UNITED STATES PATENT AND TRADEMARK OFFICE

APPLICATION NO.	FILING DATE	FIRST NAMED INVENTOR	ATTORNEY DOCKET NO.	CONFIRMATION NO.
10/644,465	08/20/2003	Henry Marshall Israel	2550-001	5945

Office Action Summary

FIG. 3A

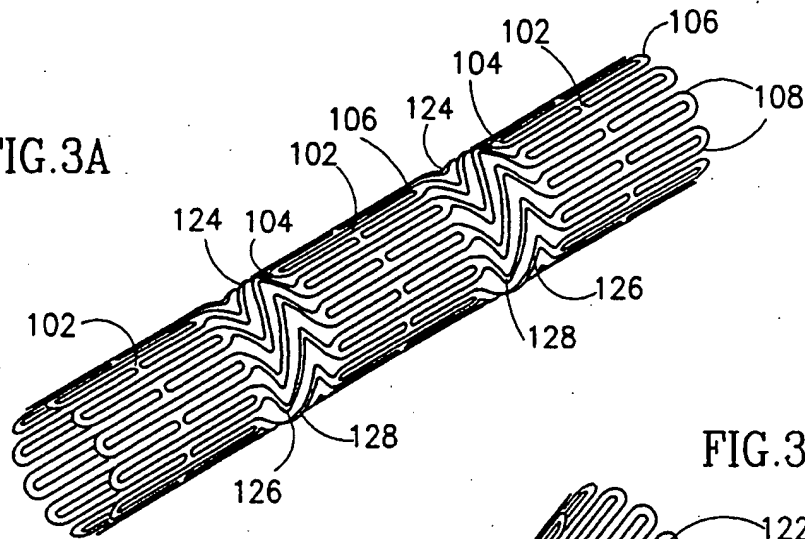
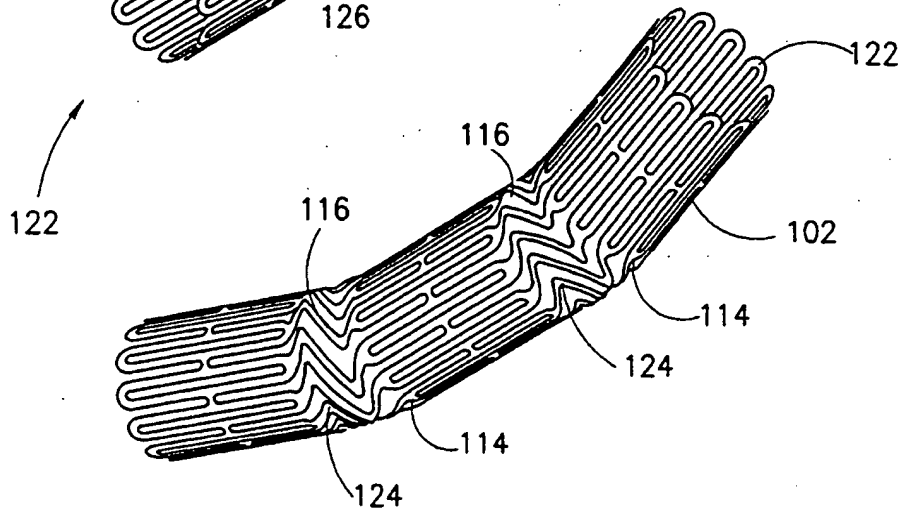
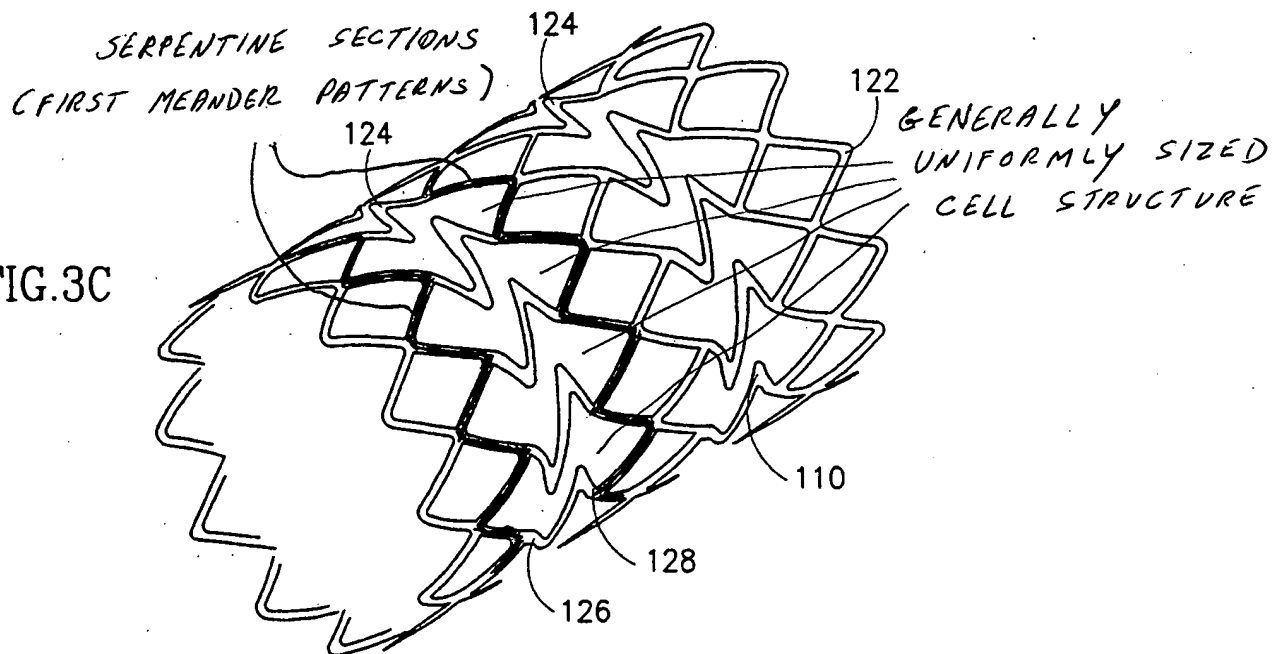
Claims 42, 44-49, 51, 57-60, 63-69 and 72 are rejected under 35 U.S.C. 102(e) as anticipated by or, in the alternative, under 35 U.S.C. 103(a) as obvious over Pinchasik et al. (5,449,373). As to claim 42, Pinchasik et al., in figures 3A-3C, disclose a plurality of continuous serpentine sections (as shown in the attached appendix A), a plurality of flexible connectors 124 forming a generally uniformly sized cell structure (as shown in appendix A), each of the connectors being

elongatable in a bend of a lumen to maintain a generally uniformly sized cell structure in the bend after expansion (the above identified cells will inherently still be generally uniformly sized in the bend since any difference between the cell sizes will be relatively small, particularly in a small bend. Alternatively, it would have been obvious that the cells will still be generally uniformly sized in the bend when the bend is small since any effect the bend would have on the cell size would be small due to the smallness of the bend. As to claim 46, the top end of the Pinchasik et al. connectors are open, closed, open and closed along the longitudinal axis of the stent from the left to the right as seen in figures 3A-3C. As to claim 57, Pinchasik et al., in figures 3A-3C, disclose first meander patterns and second meander patterns as shown in the attached appendixes A and B.

FIG. 3A

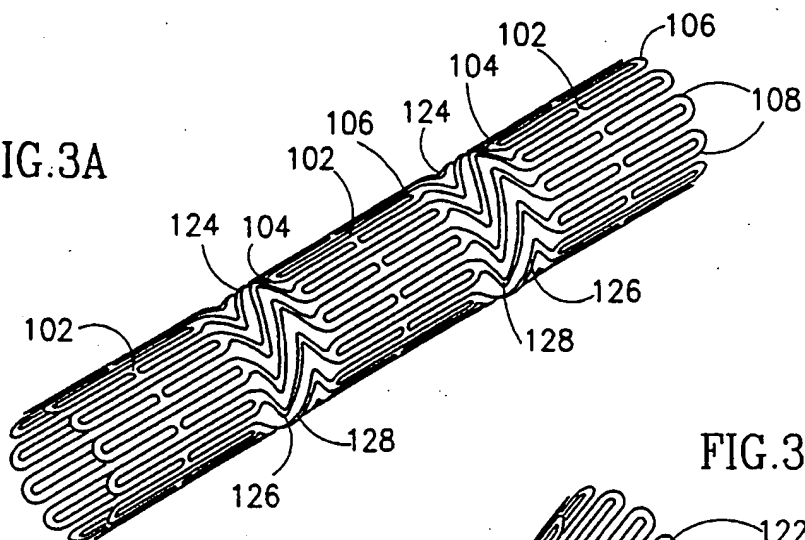
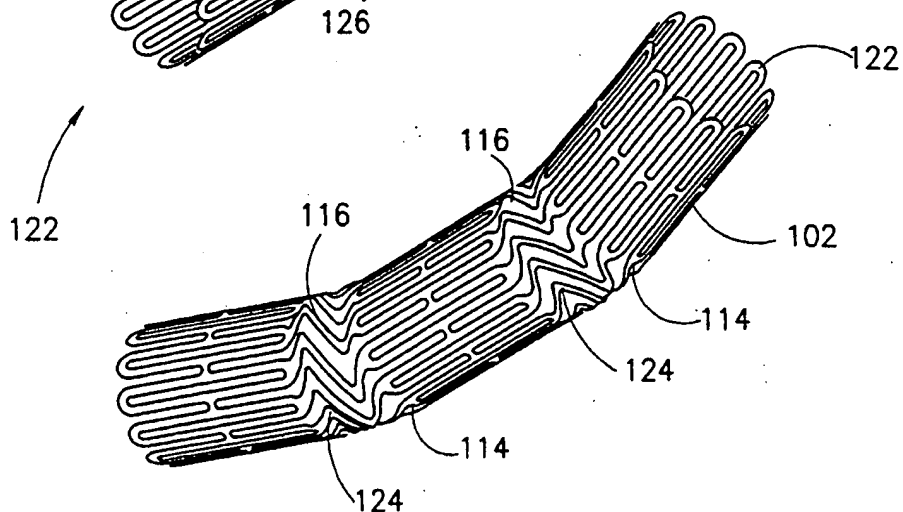
Claims 52-56, 61, 62, 70 and 71 are rejected under 35 U.S.C. 103(a) as being unpatentable over Pinchasik et al. (5,449,373). As to claims 52-56, Pinchasik et al. fail to disclose the loops 128 of the second meander pattern as having a smaller width (claim 52) or being more flexible than the loops of the first meander pattern (claim 56). However, it is old and well known in this art to reduce the width of a hinged area of a stent where bending is desired in order to obtain the advantage
